# Technical Bulletin

Roof System Update

## Brava Cedar Shake Roof System Update Removed Structural Ribbing Back from Hip & Ridge Caps

### Old vs New

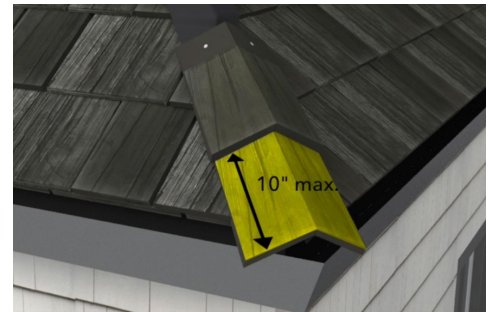
This bulletin introduces modifications made to the Hip & Ridge Caps for the Cedar Shake Roof System. Brava has improved its Cedar Shake Roof System by removing the structural ribbing on the back of the Hip & Ridge Caps. This change allows for a more natural appearance where the underside of the cap is visible at hip-to-eave and ridge-to-rake intersections. The Hip & Ridge Caps are also more flexible, allowing a more consistent fit for multiple hip and ridge angles.

**Old Structural Ribbing Back**

**New Textured Back  
No Structural Ribbing**
